April 22, 2022

RE: Metro's North Tualatin Mountains  
Case #T4-2017-9166 – Comprehensive Plan Text Amendment  
Case #T3-2017-9165 – Use Application  
**Response to Request for Additional Information**

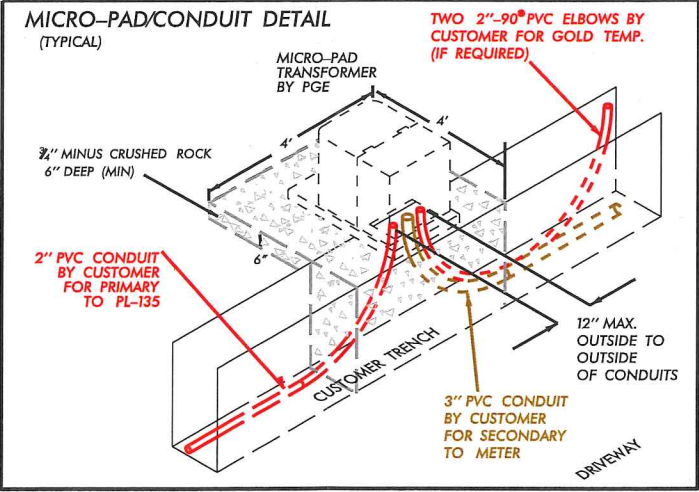
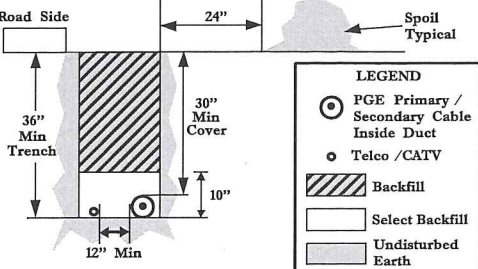
**Issue #3.** *Metro has indicated that the entry gate will be motorized, but has also indicated no electricity is proposed for the sight. Can you confirm the power source for the gate? You have already indicated the security light would be solar power, is this also true for the entry gate and the restroom light?*

Since the original application submission, solar was not found to be an adequate power source for the automated gate. Thus, power lines will be brought to the site. Attached plans from Portland General Electric indicate power will be brought to the site from NW Wapato Avenue. Lines will run underground, including under the rail line. Exhibit 1. PGE will coordinate the utility easement within the right-of-way. Lighting will be connected to the same power source. Appropriate and needed right of way permits will be obtained to support utility installation. The need to obtain said permits can be made a condition of approval to ensure compliance.

**BURLINGTON CREEK FOREST  
EROSION CONTROL AND SEDIMENT  
PROTECTION PLAN**  
McNamee Road, Multnomah County

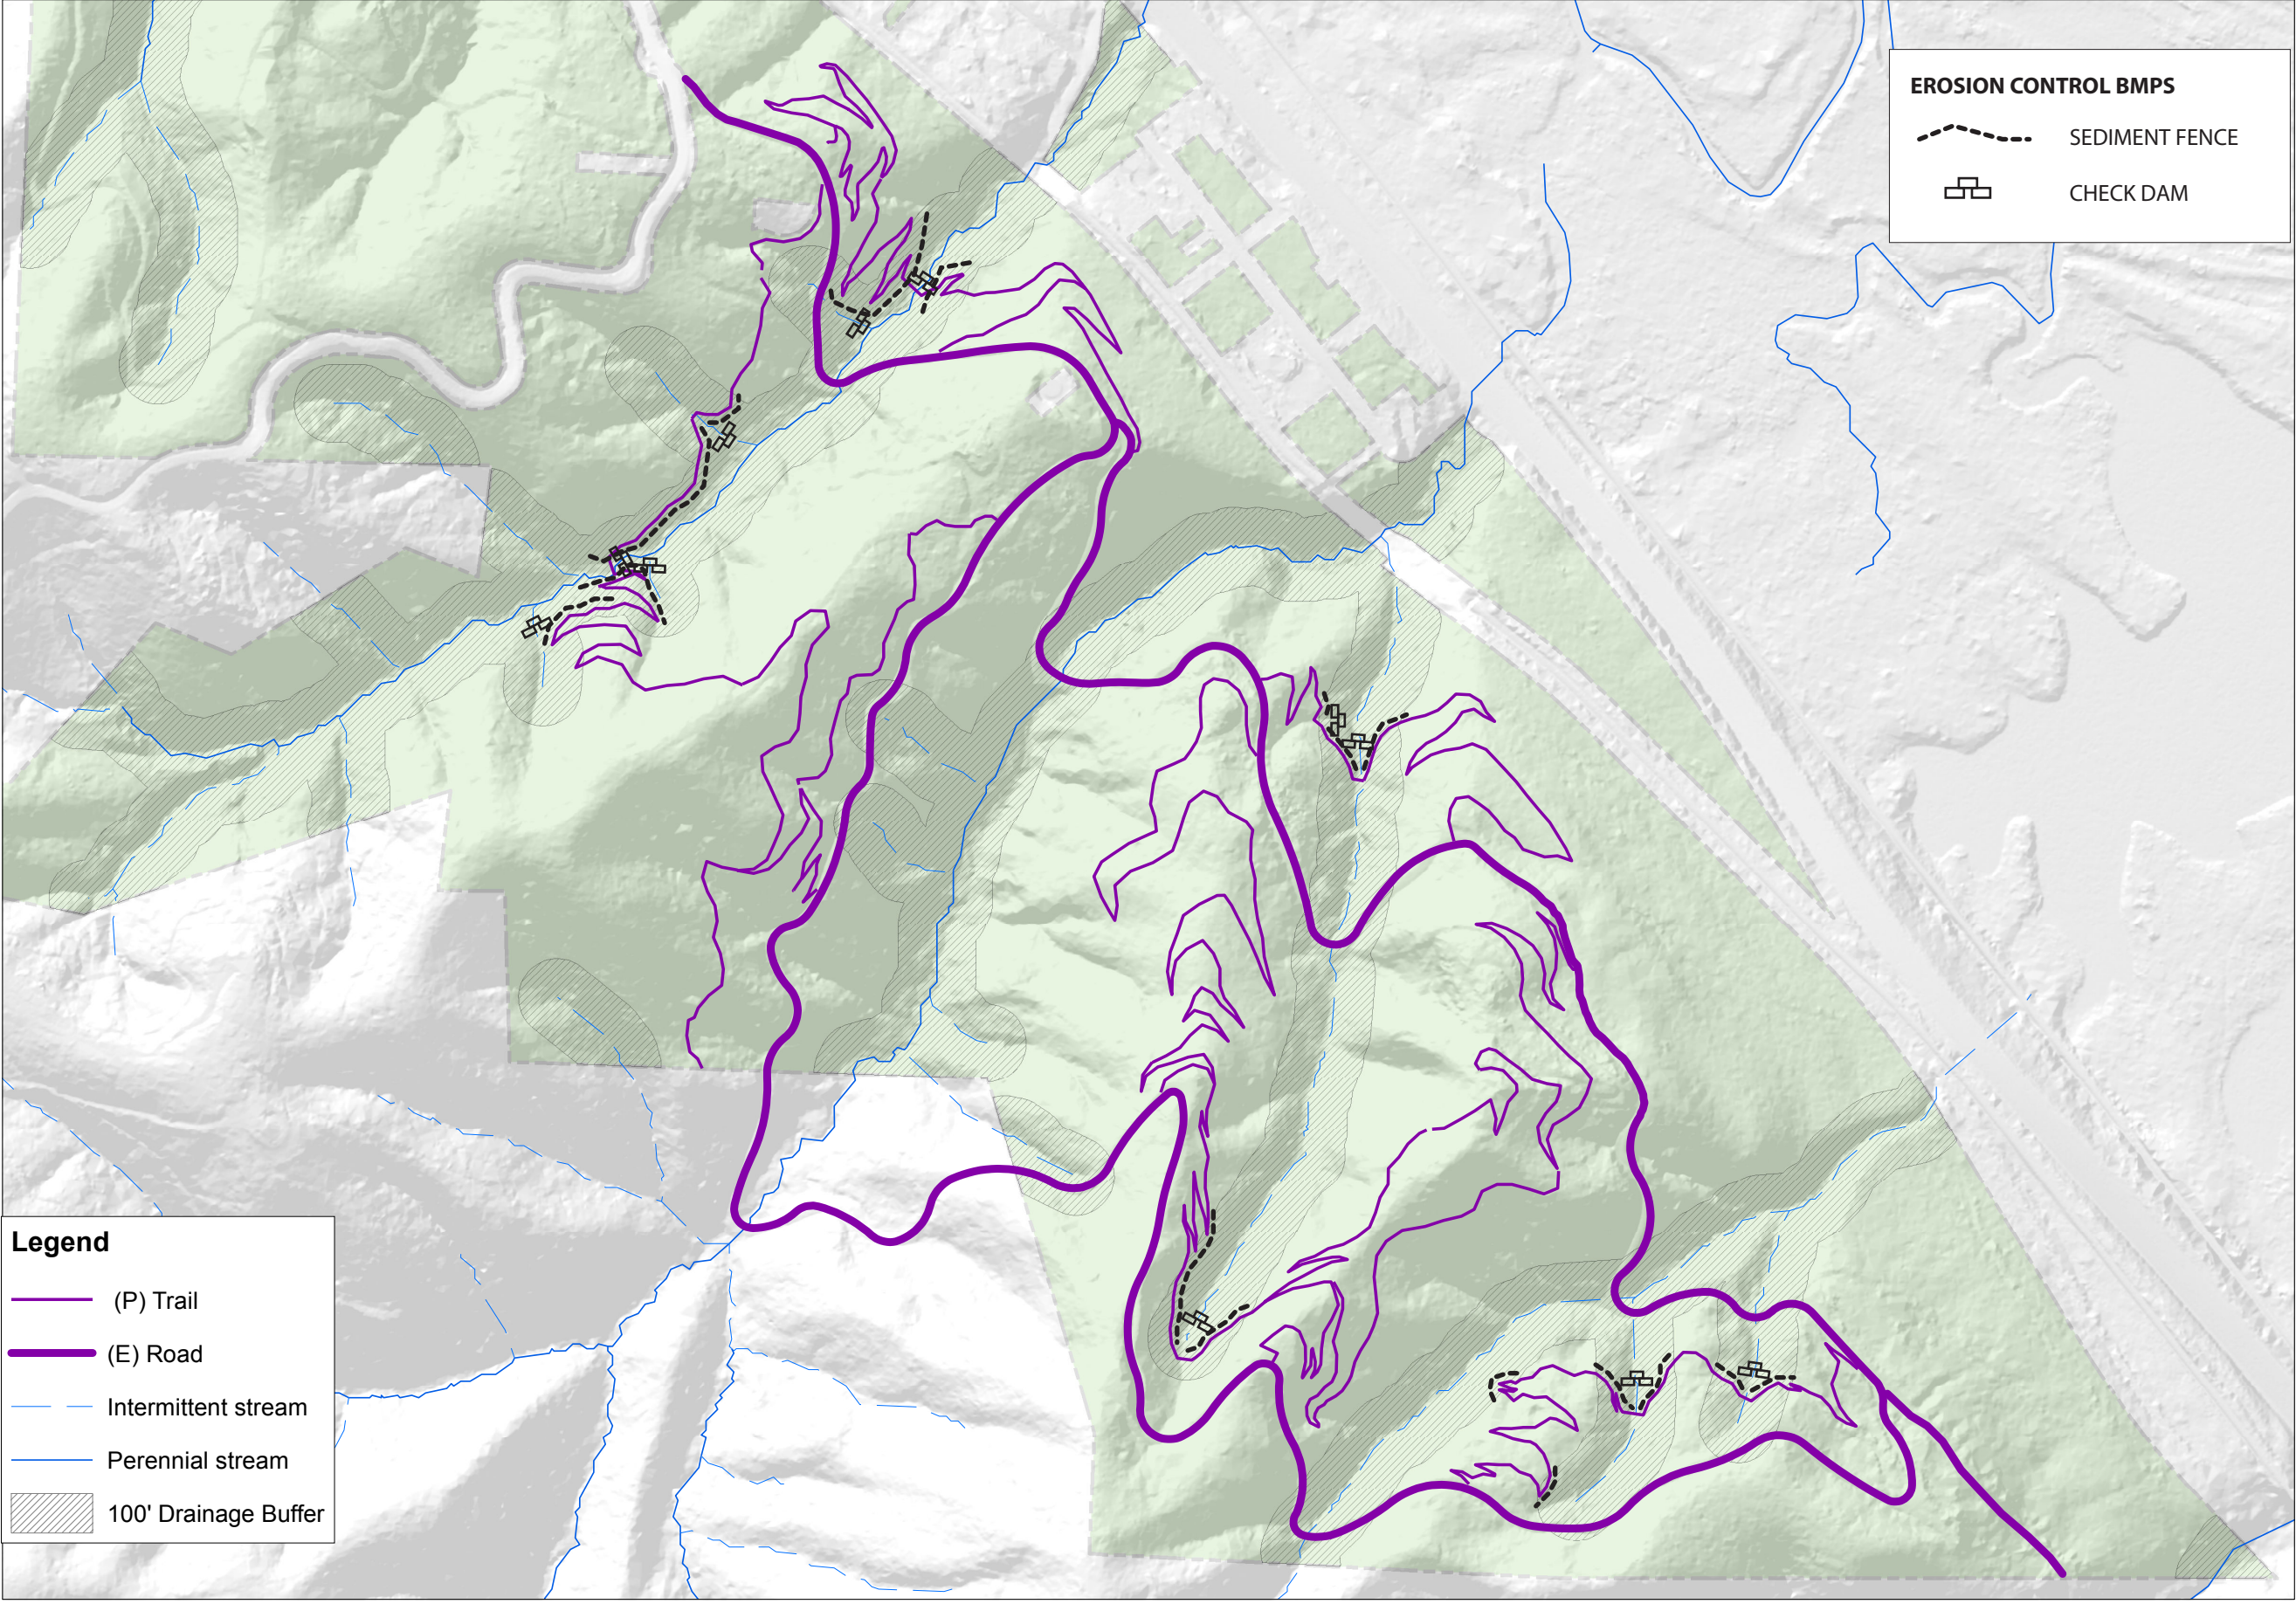
**Issue #4.** *Because stream crossings are proposed, a mitigation plan, as referenced below in subsection 2, is required. Please submit this mitigation plan as soon as possible, and let me know if you have any questions as you review the mitigation plan requirements.*

Applicant provided preliminary grading and erosion control plans depicting information required for the access and parking area. As requested by the County, attached as Exhibit 3 are additional preliminary construction management plans, erosion control best practices that will be utilized for all bridge abutments and trail construction within the buffer.

AKS DRAWING FILE: 4781 MCNAMEE SIGHT DISTANCE.DWG | LAYOUT: 5

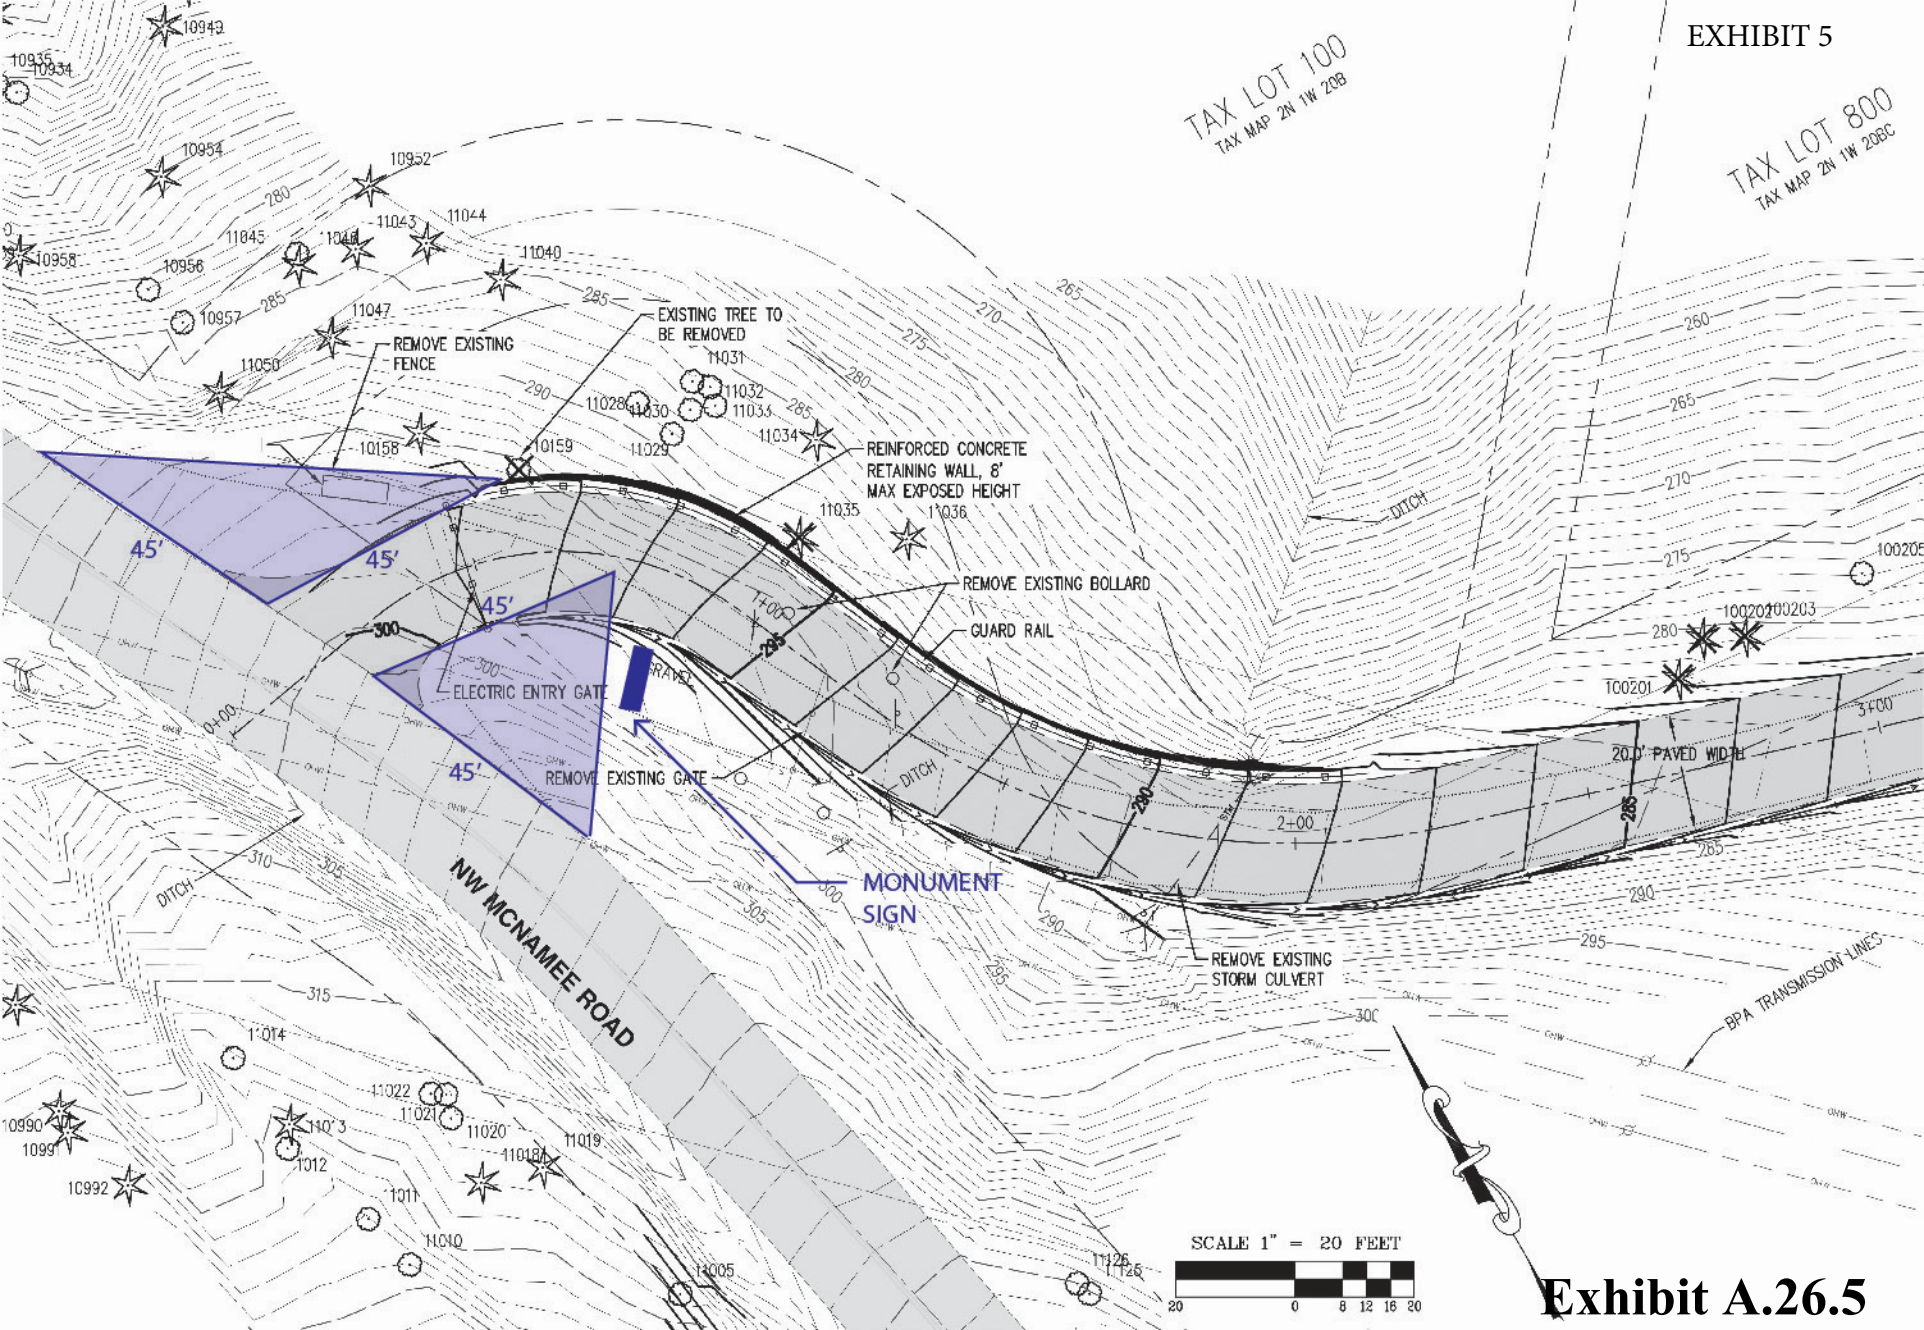
**Item #8.** *Regarding 33.7465 (Sign Placement), I believe that the monument sign at the entry may actually be proposed in the vision clearance area (a prohibited area), though the twisty shape of the driveway and the curve of the road make a somewhat difficult to measure. Can you provide a sight plan showing how the monument sign will be located outside the vision clearance area?*

Metro does not propose or intend to locate the monument sign within the vision clearance area. Any representation of such in the preliminary plans is in error. We understand the clear vision area you are concerned about is the distance the sign is set back from the road surface edges to allow clear vision in both directions, as required by Figure 2 below.

Attached as Exhibit 5 is a site plan depicting the proposed sign with reference to the vision clearance area triangle required by 33.7465 (C). Applicant requests that the standard of 33.7465(C) be made a condition of approval to ensure compliance.
